MILITARY SPECIFICATION

ASSEMBLY, KLYSTRON POWER SUPPLY: 10548905

This Amendment forms a part of Military Specification MIL-A-50655(MU) dated 15 April 1971.

Figure 1. Board Assembly Test Setup. Change:

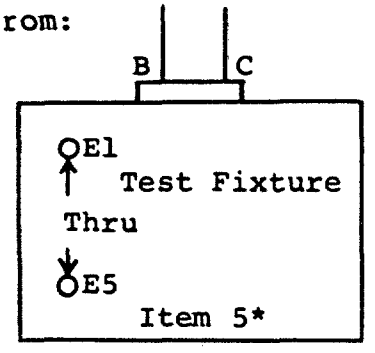
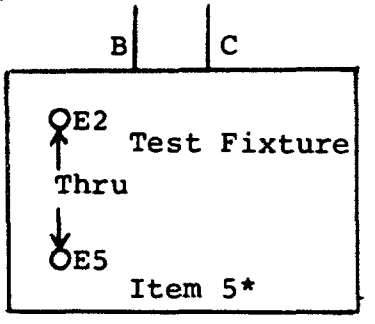
From:

To:

Figure 2. Test Fixture Setup. Change:

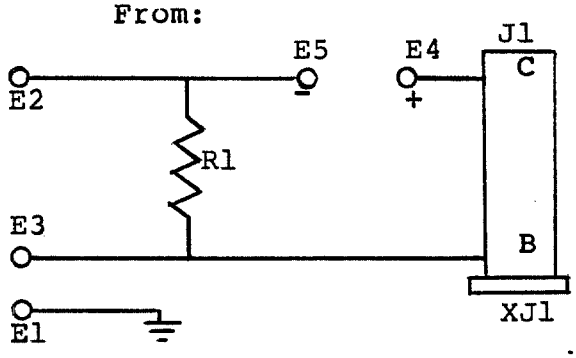
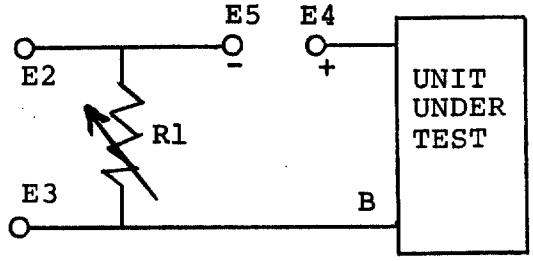
From: "J2C(+) and J2B(-)."
To: "E2(+) and E3(-), Figure 2."

From:

To:
